HOUSE OF DELEGATES

November 6, 1979

POWER PLANT CUMULATIVE ENVIRONMENTAL IMPACT REPORT

RADIOLOGICAL EFFECTS

Figure IV-1. Locations of radionuclide discharges into Chesapeake Bay

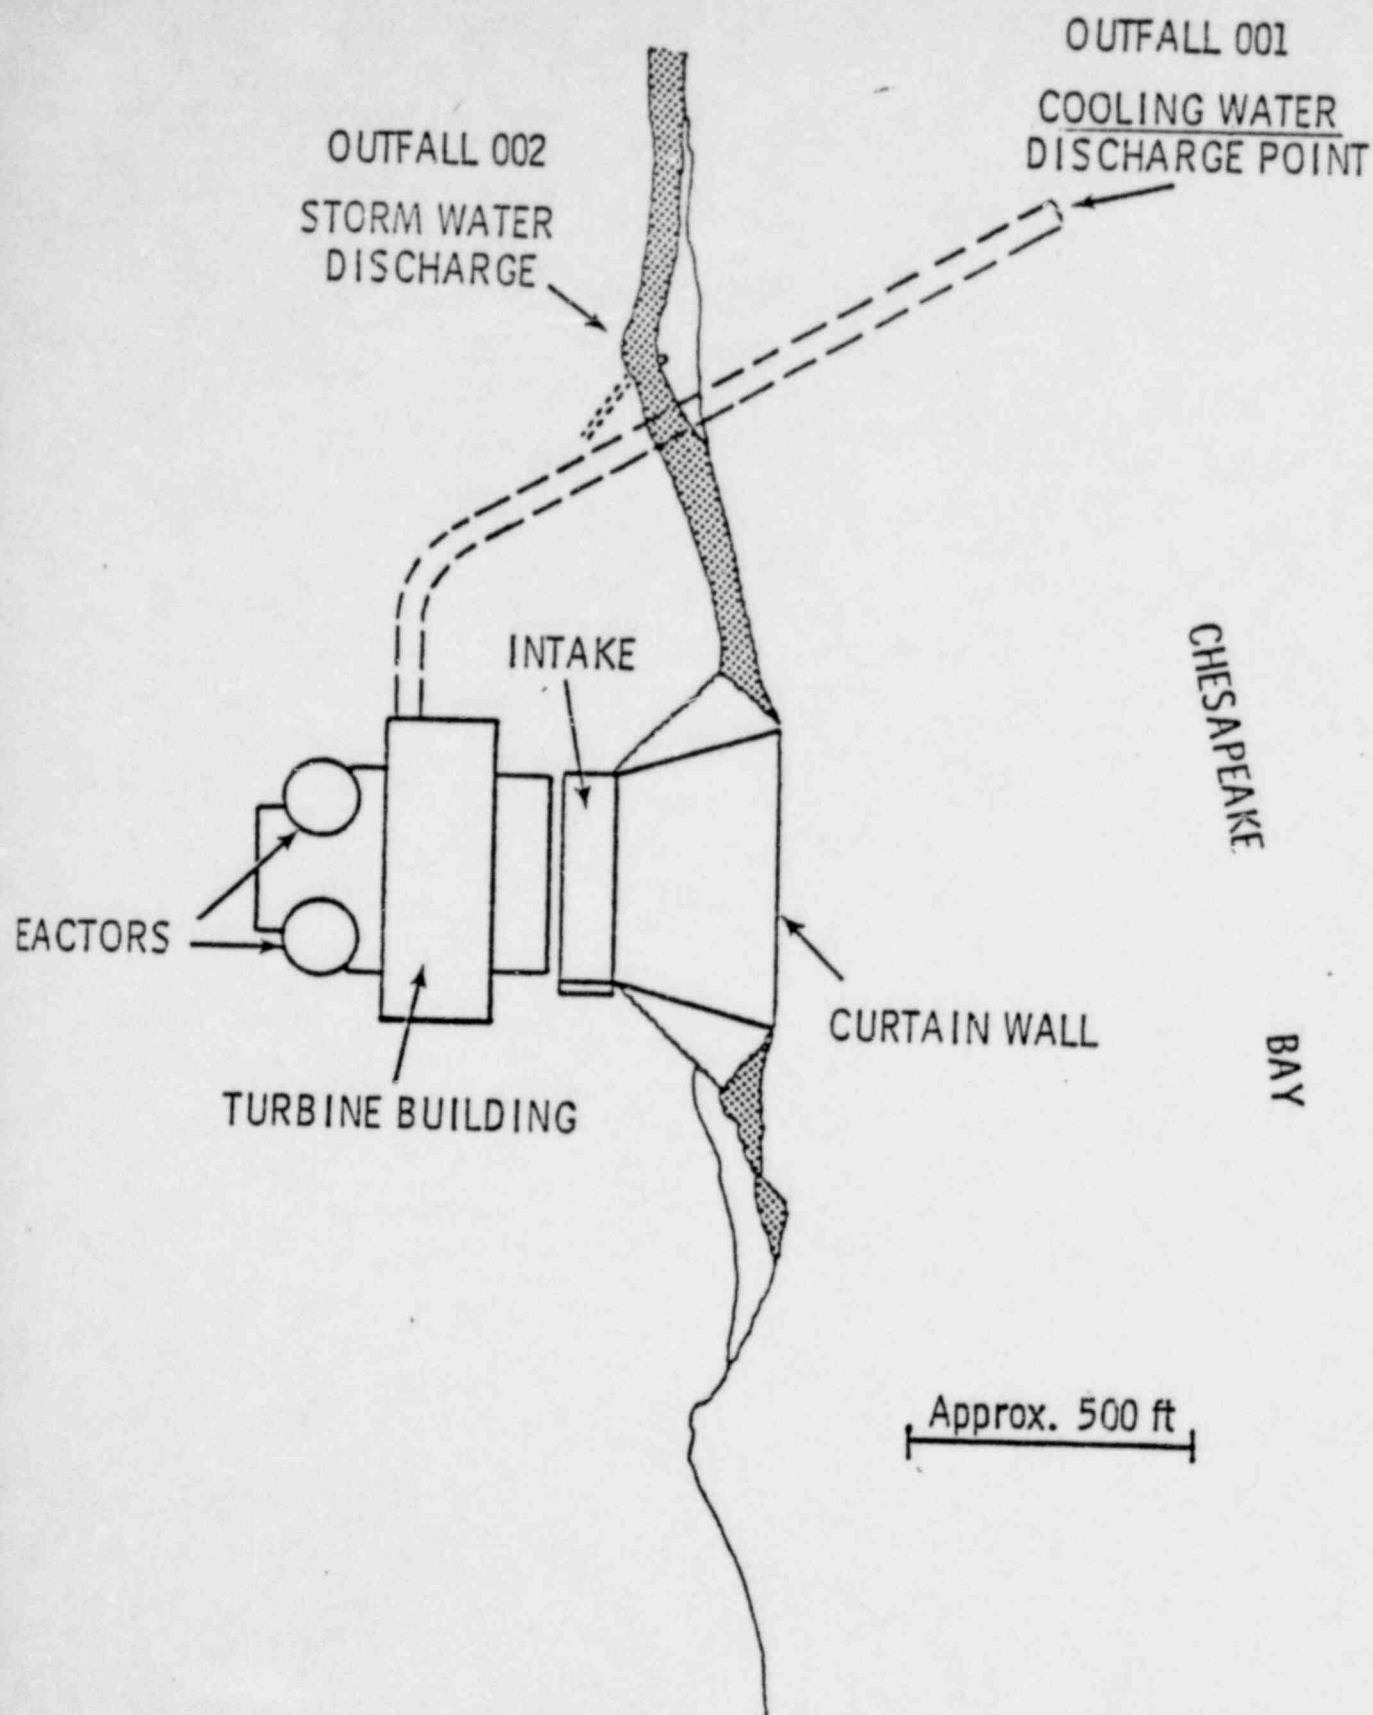
5. Storm water runoff samples at the Calvert Cliffs plant have contained these radioactive isotopes: Co-60, Co-58, Mn-54, Cx-134, and Cs-137. Is this cause for concern?

Discharges of radionuclides to the Bay were predicted to occur only through the cooling water discharge conduit (see Figure IV-1). However, sampling of storm water runoff and the sand below the storm water outfall pipe 002 have revealed that minor amounts of radioactivity are also being discharged by this path (37). At least two discrete incidents (38,39) reported by BG&E to the Maryland Water Resources Administration have been responsible for discharges of radioactive material from this outfall. Continued discharge of barely detectable radioactivity may be due either to continued flushing of contamination caused by these two incidents, or by some other source. Isotopes associated with this discharge include Co-60, Co-58, Mn-54, Cs-134, and Cs-137. Sampling of shorezone fishes, oysters and sediments in close proximity to this outfall has indicated that the radioactivity discharged from the storm drain has probably not made any detectable contribution to radionuclide concentrations in the Bay. This is due in part to the (assumed) small quantity of radionuclides discharged, but also, in large degree, it is due to the rapid dispersion of effluents once they cross the beach and enter Chesapeake Bay. This finding, that some radioactivity may be discharged into stormdrains, should be carefully considered when evaluating other nuclear power plant designs which may be proposed for sites where storm water runoff enters creeks or other natural water bodies with poor natural flushing.

Figure IV-2. (A) Gamma spectron of oysters from Calvert Cliffs Nuclear Power Plant discharge area showing effluent radionuclide bioaccumulation

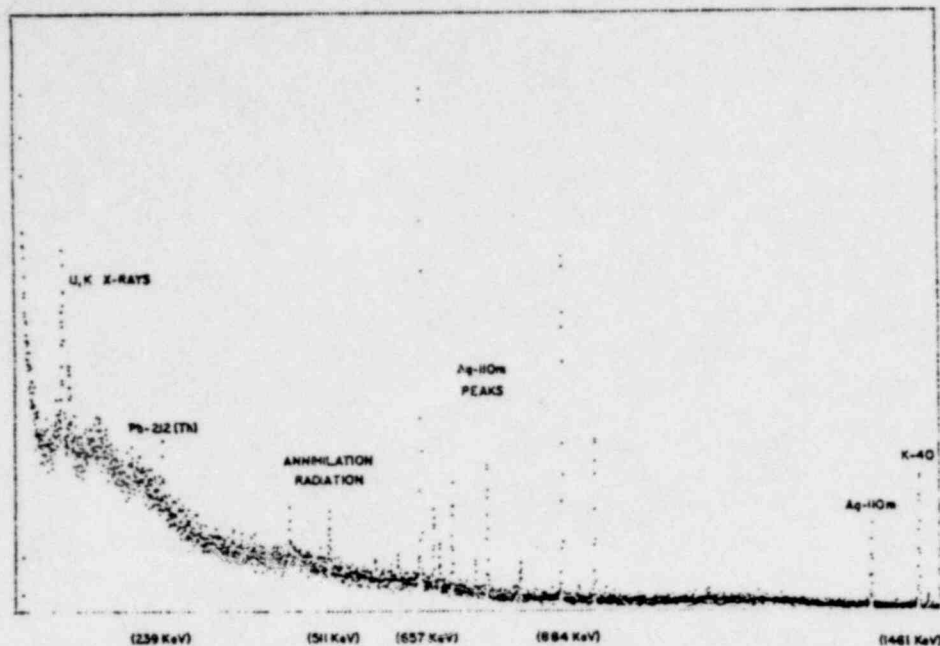
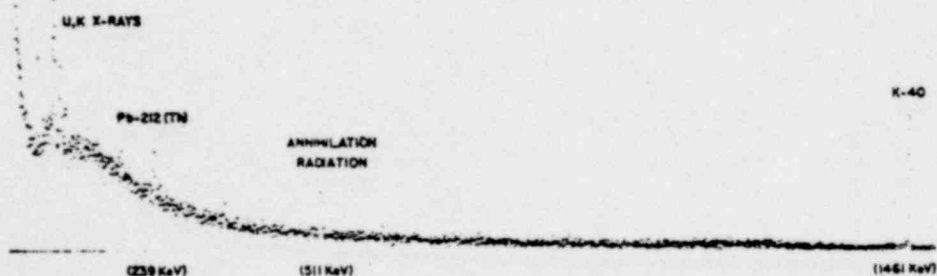
6. Ag-110m has been found in oysters six miles from the plant. This isotope was not one of the predicted liquid effluents. Is this concentration of Ag-110m in sediments and oysters near and as far as six miles from the plant cause for concern?

7. Can you comment on the analysis on page IV-19 and the chart at Page IV-21 that Ag-110m, Co-58 and Co-60 doses found in oysters near the plant produce risk levels when eaten by humans that "are minuscule compared to the normal risk levels. . . of the U.S. population today"?

Figure IV-2a and IV-2b demonstrate that Ag-110m has become the predominant radioisotope in oysters near the power plant discharge. However, the dose received by an individual eating these oysters is quite small. An adult would receive a dose of 0.000009 mrem to the whole body and 0.006 mrem to the gastrointestinal tract by eating one dozen "select" (large) oysters with a Ag-110m concentration of 500 pCi/Kg.*
